DEPARTMENT OF VETERANS AFFAIRS
Veterans Health Administration
National Health Physics Program
2200 Fort Roots Drive
North Little Rock, AR 72114

In reference to NRC Master Materials License 03-23853-01VA, we are requesting release, for unrestricted use, of an incinerator and associated smoke stack adjacent to Building 4 at VA Medical Center, Kansas City, Missouri. The facility holds Permit Number 24-00496-06 under our master materials license. Pending approval by NRC and a permit amendment by VHA National Health Physics Program (NHPP), the permittee plans to demolish the incinerator building and associated stack. We are enclosing supporting information and closeout surveys that were performed by the permittee to support release of the structures. We request an expedited review of this request by NRC, if possible, since the permittee states the stack poses "a safety hazard to approaching and departing ambulance helicopters."

Subject: Decommissioning of Incinerator and smoke stack

Subj: Close out survey of Building 4 Incinerator Chamber

Building 4 Boiler Plant Incinerator Chamber Fire Brick Sampling Diagram

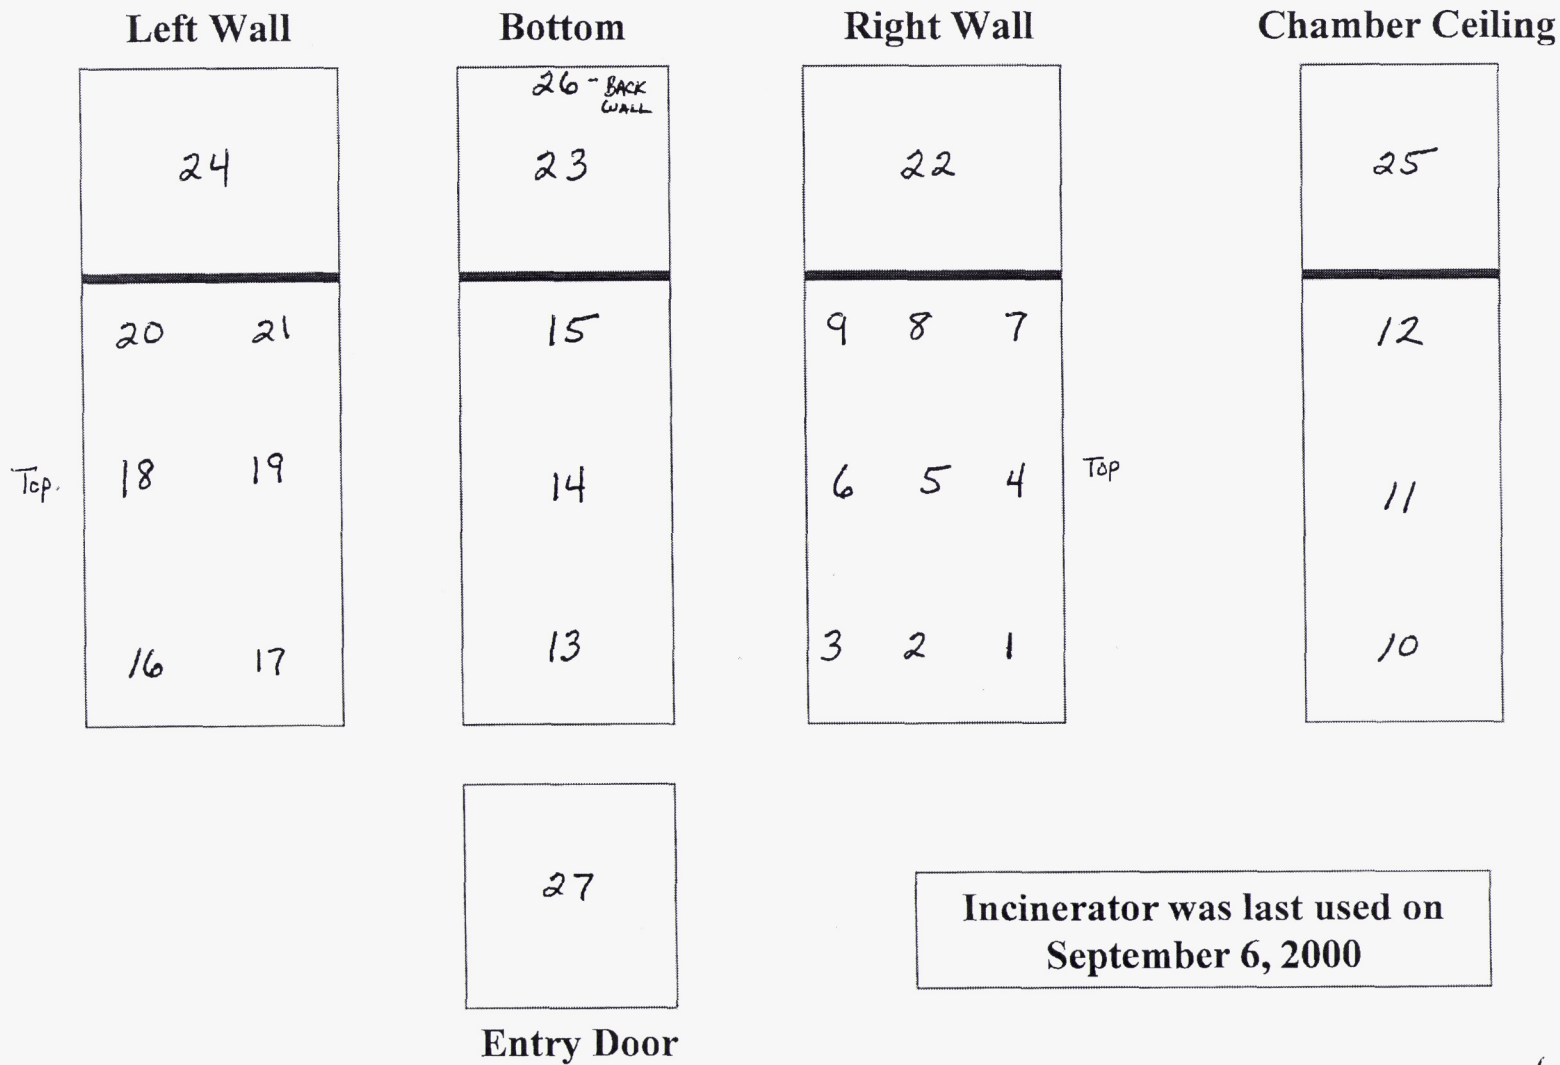
1. The sample number in each box corresponds to a grid number on the chamber diagram.
2. Exposure rate measurements in mR per hour. Background readings: <0.02 mR/hr
3. Dpm swipe survey results, in disintegrations per minute per 100 cm² for three energy levels. The firebrick surface was scraped in the specified areas in an area of about 4" x 4". The scraped particles were placed in individual glass vials for future processing. Each sample was weighed and placed in a clean 20 ml glass scintillation vial with 10 ml of Packard "Opti-Fluor counting cocktail and allowed to settle in the dark for 2 days. A Beckman liquid scintillation counter was used to count each sample for 10 minutes in a ³H, ¹²⁵I, and wide window setting. Each sample was counted 3 times and the data was averaged.
4. See attached diagram and spread sheet for data.

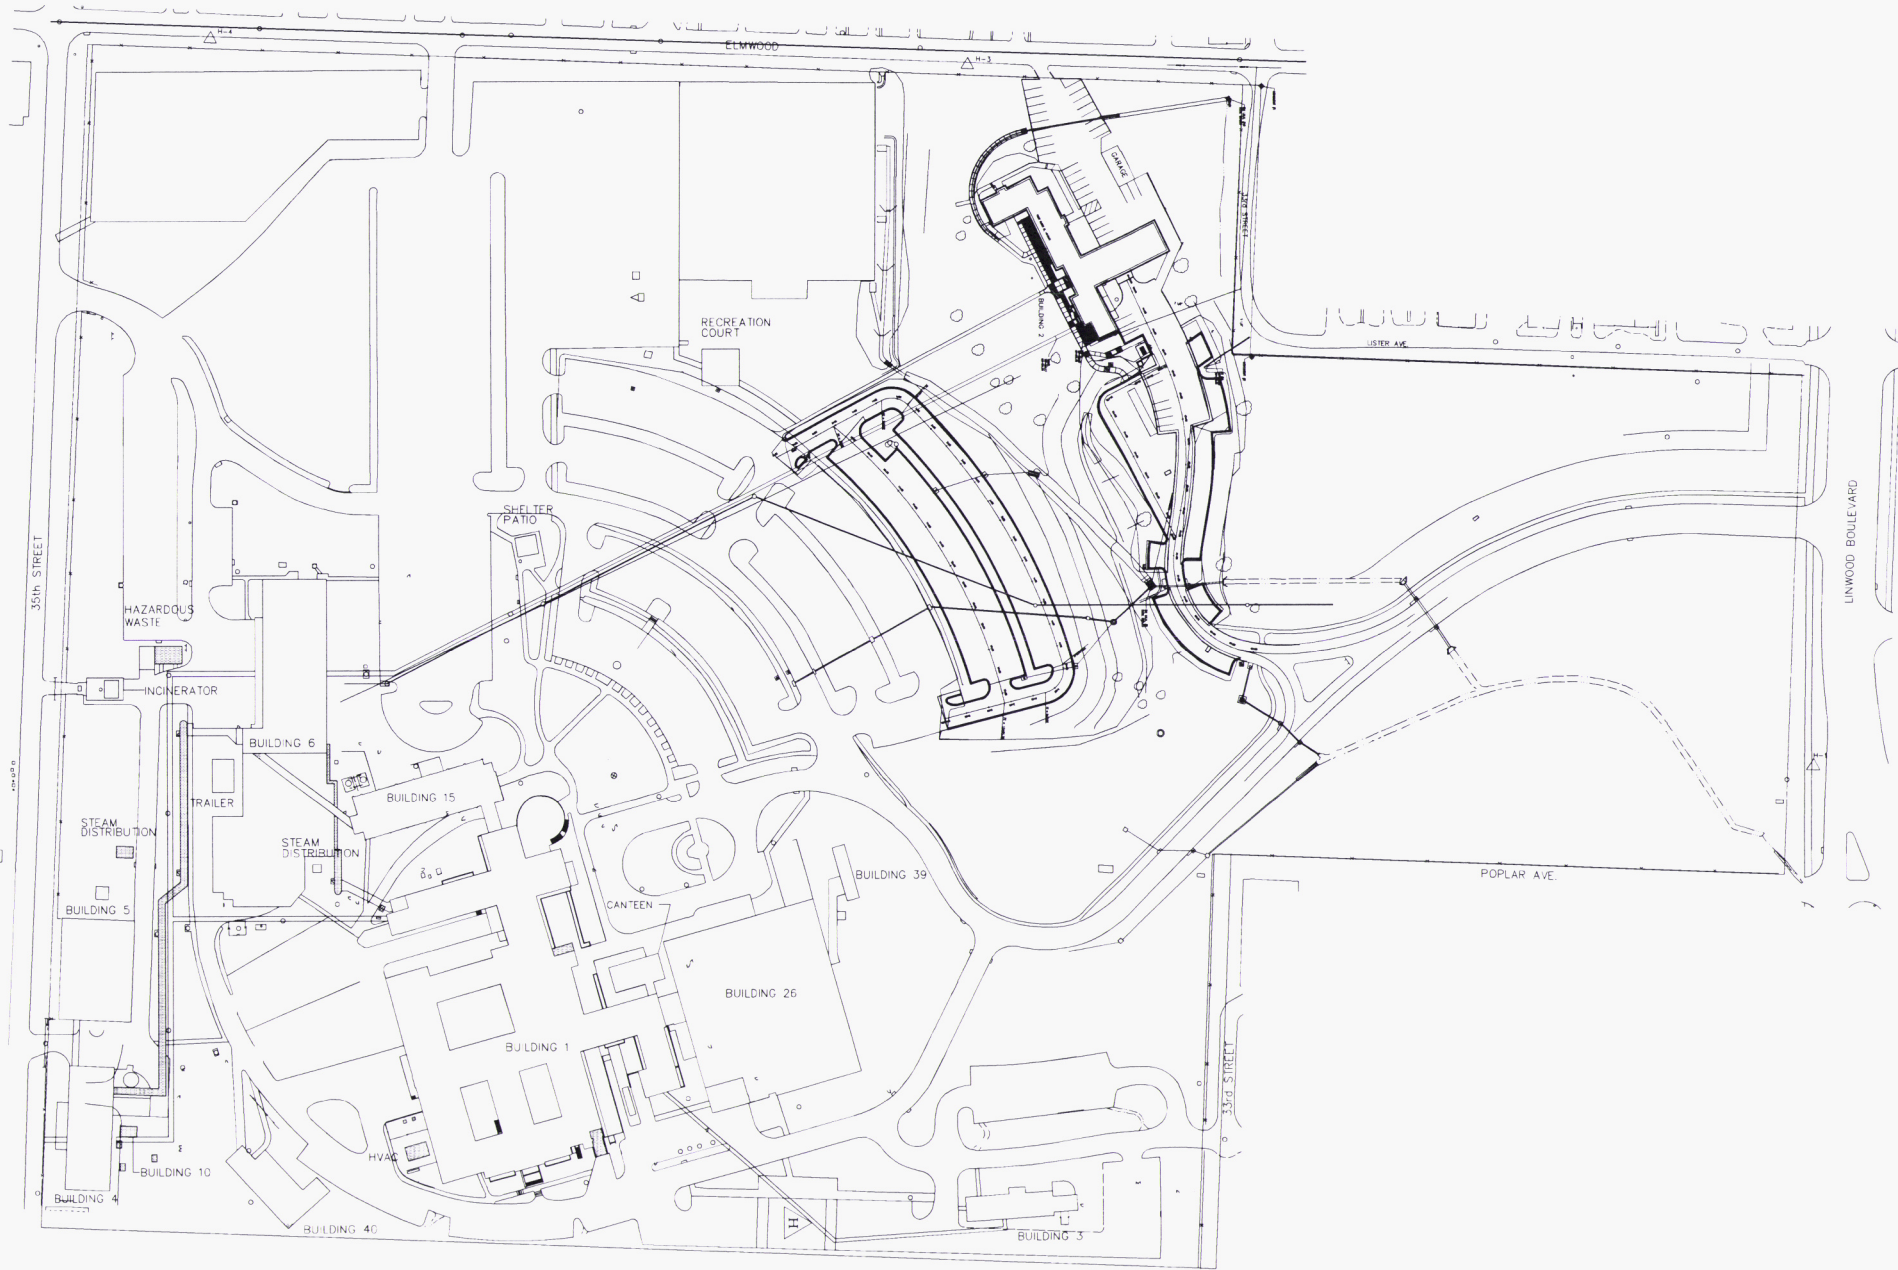
Attached is a copy of the site diagram that you requested. It is a PDF format so you should be able to view and print the diagram easily. There are 2 points that I need to bring to your attention on this diagram.

1. The smoke stack that we are requesting decommissioning of is the circle, located in the lower right hand corner. It is just above the upper left corner of Building 4. The incinerator that we are requesting to be decommissioned is located in an extension of Building 4, just to the right of the smoke stack. The structure between the smoke stack and the extension of Building 4 is an above ground walkway.

2. If you look at the bottom of the diagram and towards the middle, you will see a small building structure that is labeled, "Incinerator". This building is a small 2 level building. I have found out that this building housed an incinerator, which was used for the incineration of radioactive waste prior to the current incinerator that we are requesting decommissioning of. This previous incinerator started operation approximately 1975, was located in the lower part of the building. This incinerator was approved by the NRC for incineration of radioactive material in May of 1980, as part of Amendment #41. This incinerator was removed many years ago and the building has been used for storage. I have not been able to find any records of what materials were actually burned. According to a March 28, 1980 request, the anticipated isotopes to be incinerated were: H-3, C-14, I-125, P-32, V-48, S-35, Fe-55, Fe-59 and Se-75. Animal carcasses (rabbits, rats and mice) would be used with an anticipated activity range of 1- 10 uCi per animal would be incinerated as well as flammable liquid scintillation cocktail. I have not been able to find, at this point in time, any information pertaining to the release of this building by the NRC.

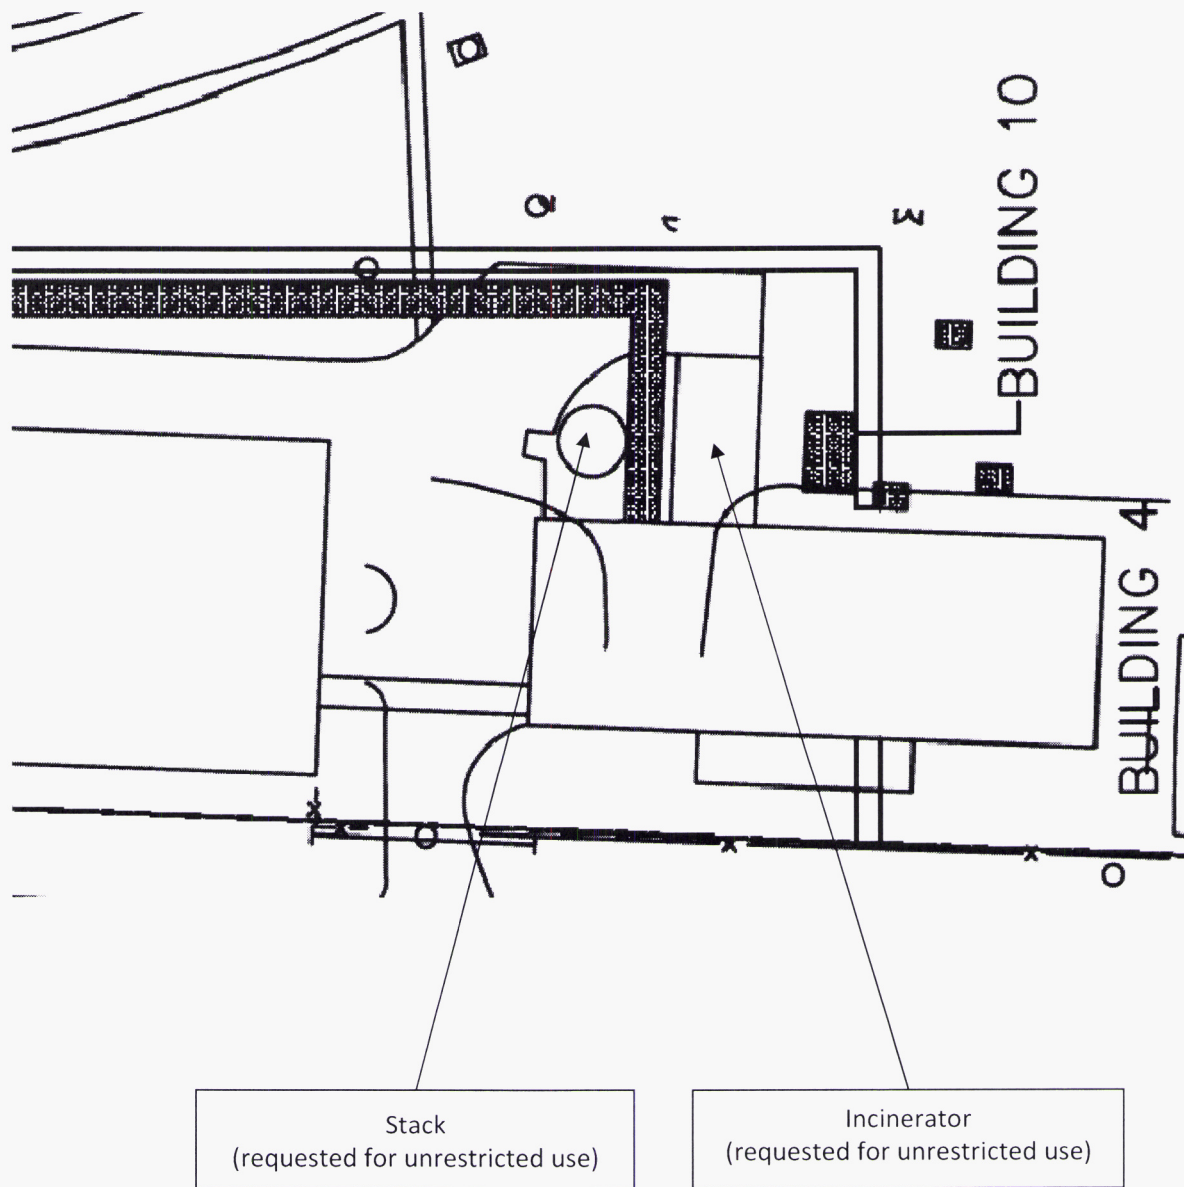
I am attaching an annotated version of your drawing to identify more clearly for NRC the stack and incinerator subject to the current request for release. Please confirm (by email back to me) that I have correctly marked those two areas.

Yes, the two areas are marked appropriately.
